RE: Pier 70 Special Use District
Building 2 Historic Rehabilitation Design Review Application – “Approval” Letter

PIER 70 BUILDING 2
REVISED_Schematic Design Package

RESPONSE TO PORT DESIGN REVIEW ANALYSIS COMMENTS - Dated 10/22/20

SOUTH ELEVATION

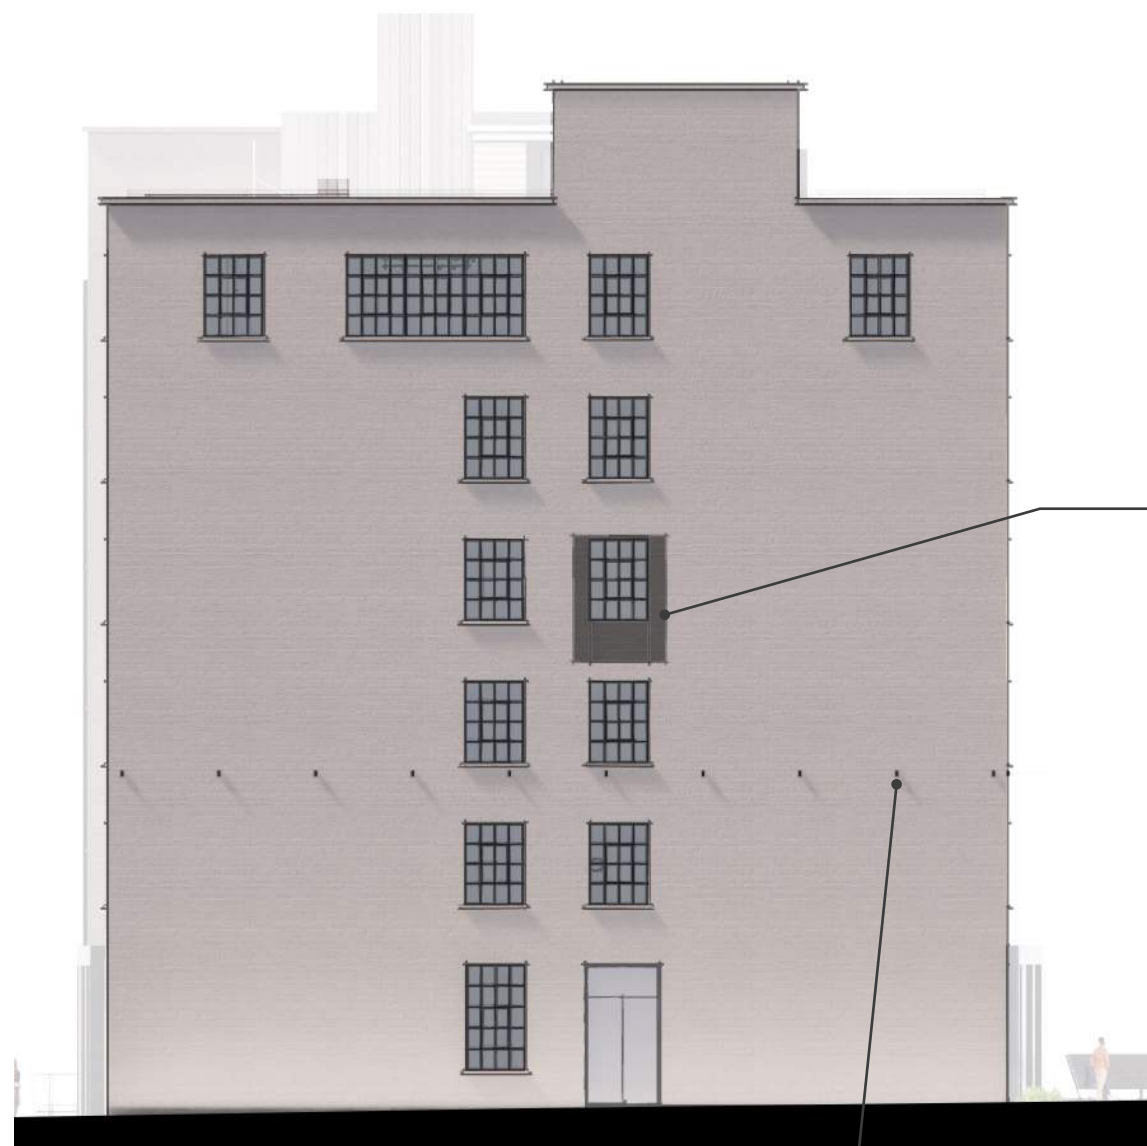
2. Port staff continue to have concerns about the design approach to the commemoration of the former openings on Buildings 2 and 12 to the historic connecting bridge that was authorized for removal by the Port. The proposed design treatment should include visual evidence of the former openings and support the ability to reintroduce a connecting bridge if needed by future tenancies; therefore, please continue to work closely with Port staff during the design development phase to address these concerns prior to submittal of construction drawings.

3. South Elevation Bridge Opening (Sheet A3.03): per previous discussions, please address how the design of the south elevation will recognize the former bridge opening that has recently been demolished and a window is now proposed. In addition to the proposed window, what are some design techniques that could highlight and identify the uniqueness of the former bridge opening?

RESPONSE #3: See Page 18 of the Design Overview Package and Sheet A3.03 for additional information. Design Intent is to provide an accent color (exact color tbd) at the extents of the historic bridge outline at the South facade, and additionally to slightly recess the concrete infill below the new window to denote the historic door location.

Accent Color at Historic Bridge Location w/ Recessed Infill at Door Location

PROPOSED CONDITION (WEST FACADE)

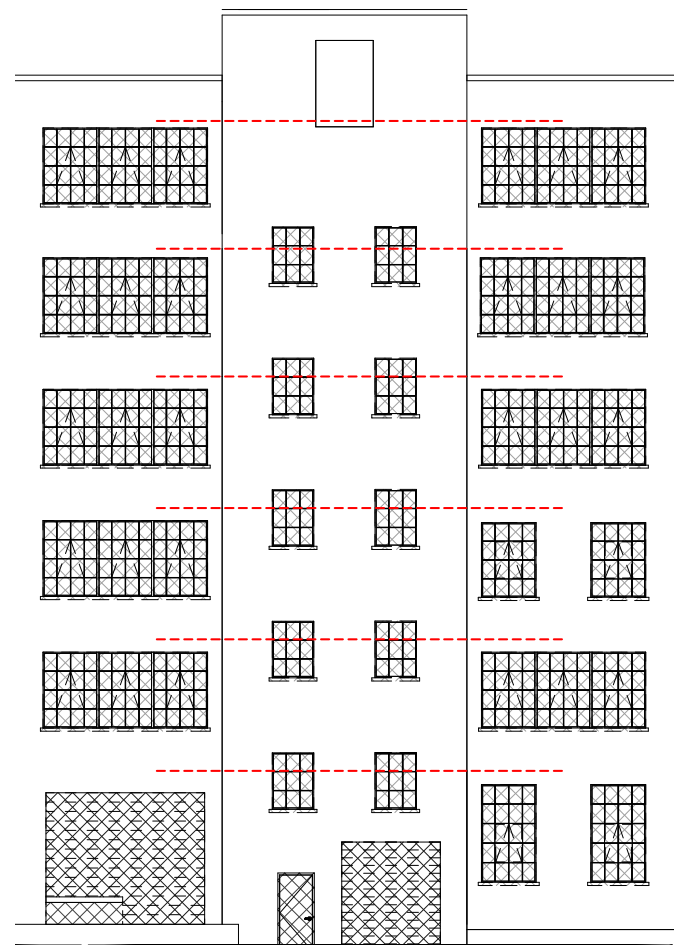
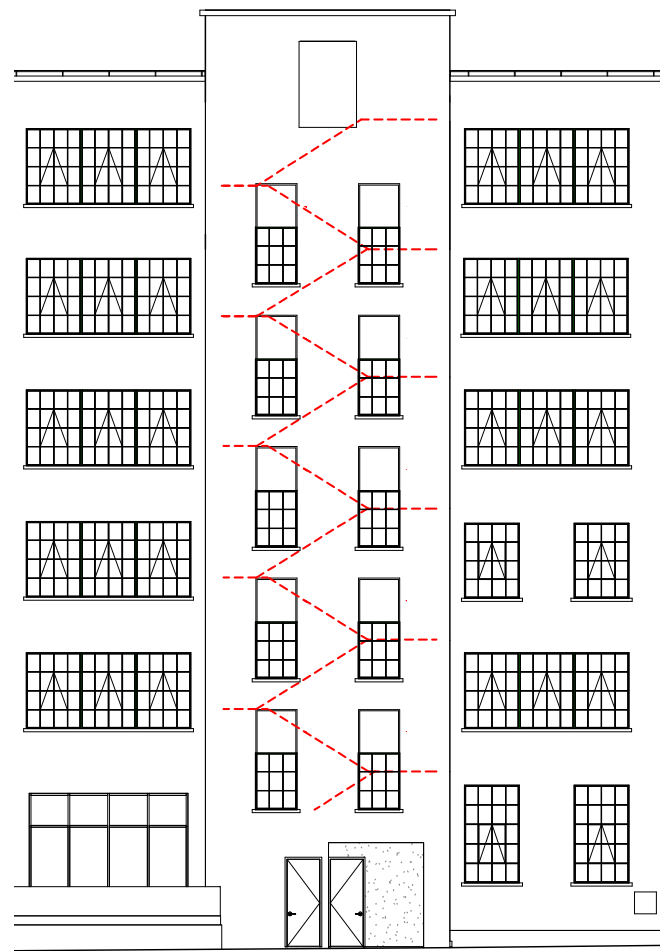
Goal: enhance the Building's connection to 21st by accentuating the historic openings with vertically enlarged openings that also provide more light to an activated interior stairwell

Enlarged openings (vertically) provide additional light and visibility for the reconfigured stairwell. Existing opening infill window to be multi-lite, while new window area to be detailed to contrast

MURAL OPPORTUNITIES

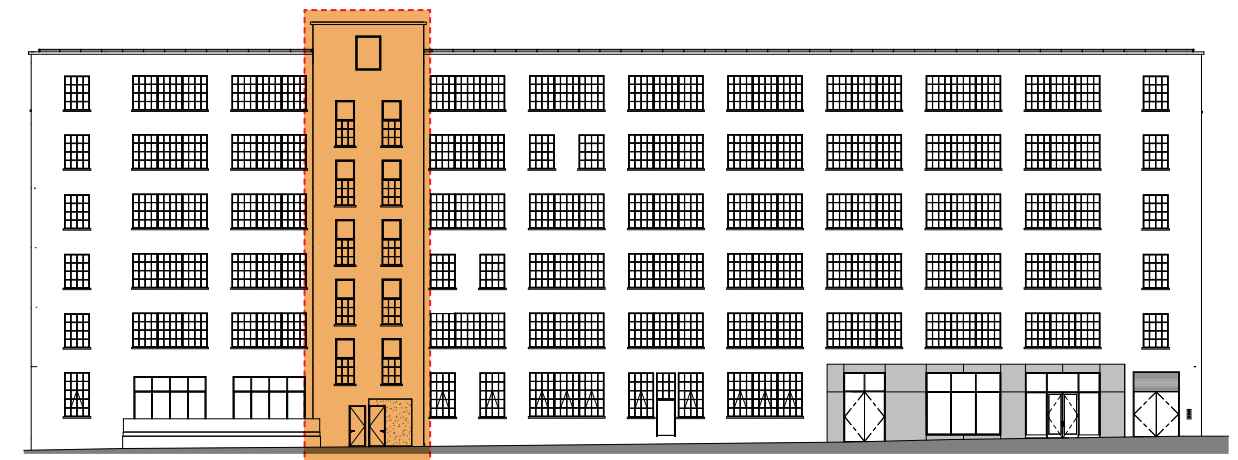
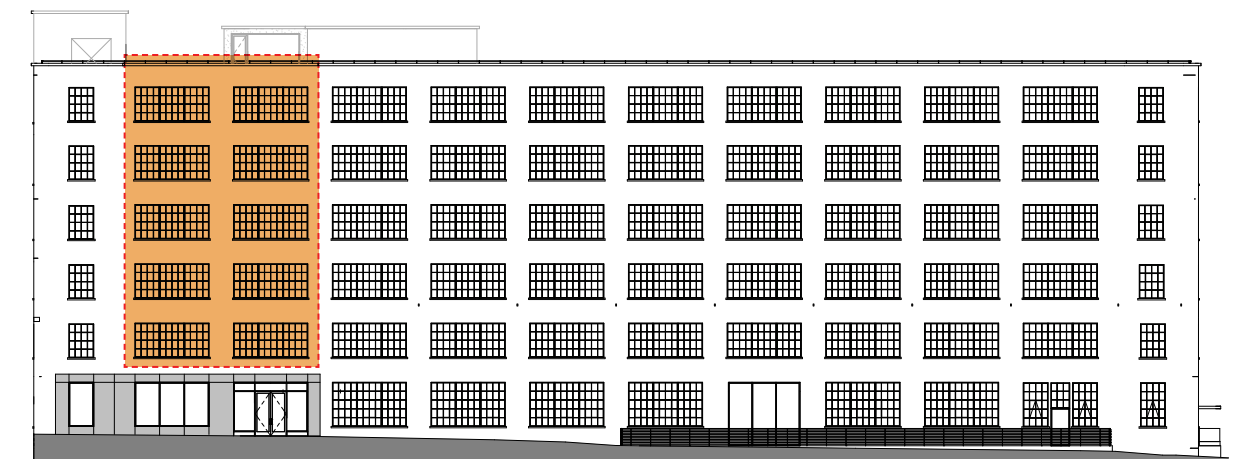
1. On the exterior of the building, if the extent of the exterior concrete repair and patching cannot be accomplished without creating an unacceptable exterior appearance, the Port may consider authorization of the application of coatings or murals as a means to create a more uniform exterior finish.

- a. Any proposed murals on the exterior of the building shall undergo staff review for further analysis and approval, prior to review of permits and/or construction drawings.

Goal: activate the pedestrian narrow alley between Building 2 and Building 12 by the use of an applied mural (final mural to be developed). Opportunities to connect public open space with building by use of mural graphics on east facade. Potentially conceal heavily deteriorated concrete repair areas.

OPTION B

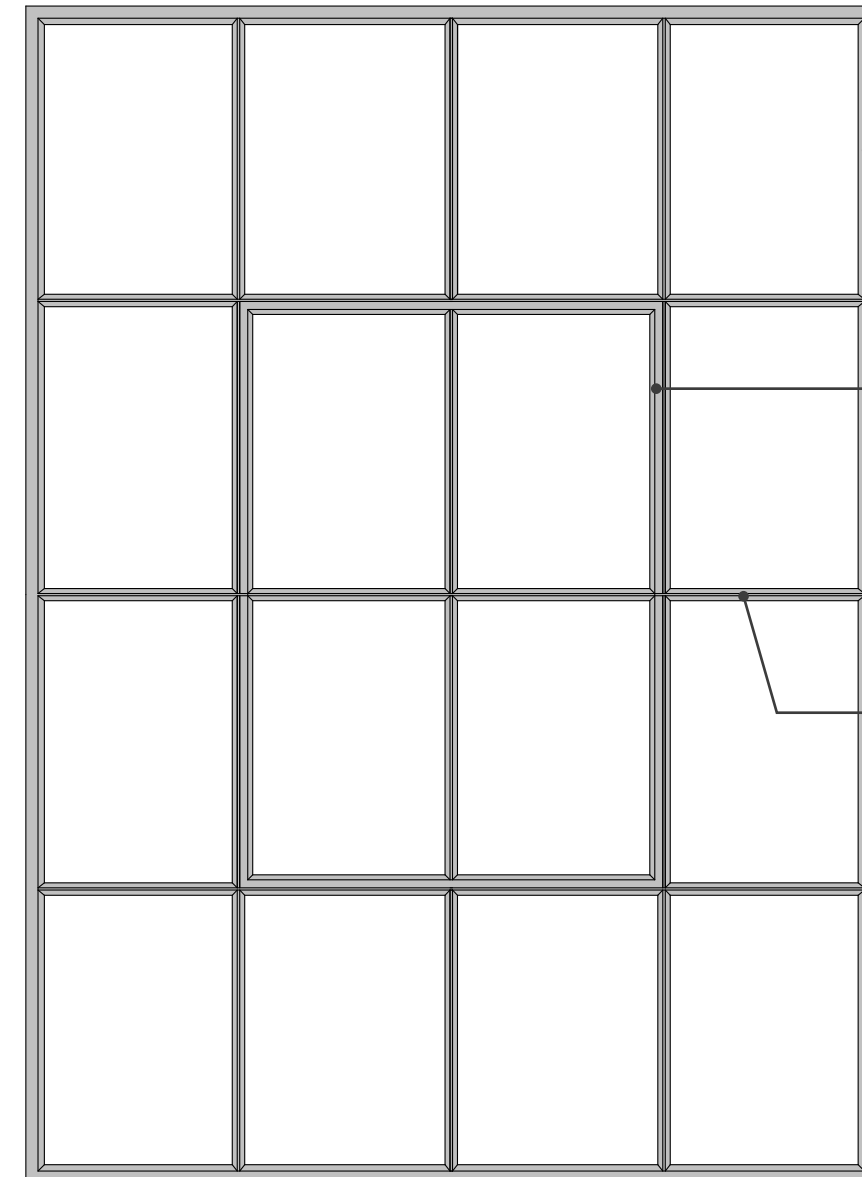
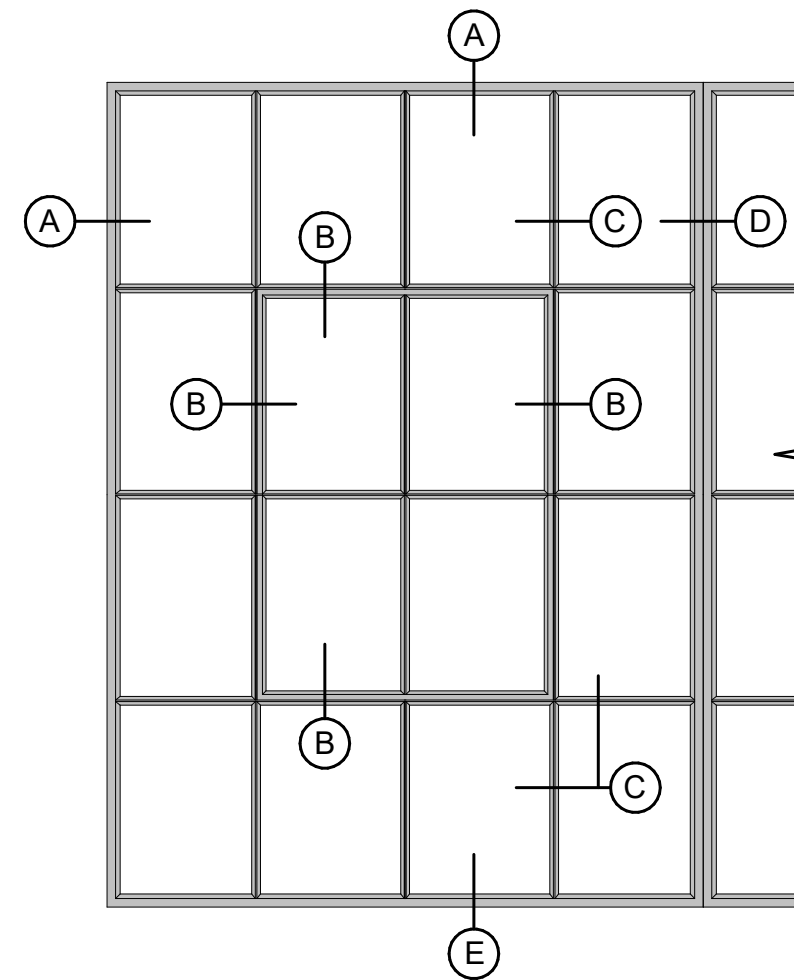
A scaled down window mock-up was reviewed on site with Port staff on 11/16/20. Port staff commented that the muntins and frame that mimic the appearance of the operable lite in the original window appeared to be much thicker than the original. In response, we are proposing Option B below, in which the muntins surrounding this fixed former-operable panel have been narrowed to more closely match the historic appearance of the operable lite.

PROPOSED PROFILES PER FEEDBACK AND MFR DISCUSSION
